Subject: Change to SAE/USCAR-18, Rev 4 (Letter #3)

This letter describes two pending updates to SAE/USCAR-18.

Figure 3Y - Female Contact

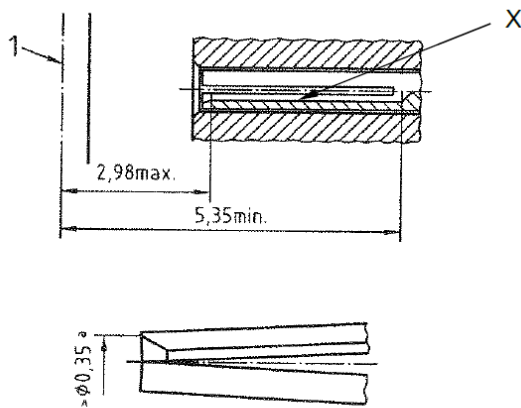
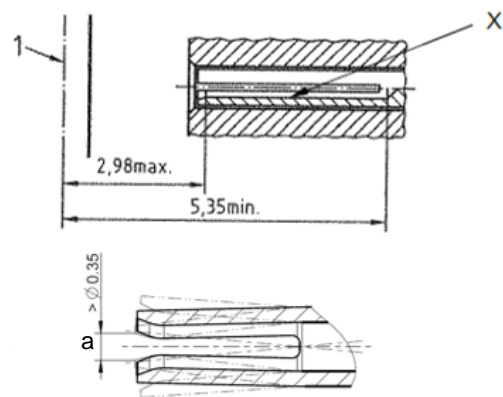
- 1) Figure 3Y Female Contact is being updated to add clarity of the catch circle intent
- 2) Changing description in 3.2 Female Connector shown for reference only

Change #1
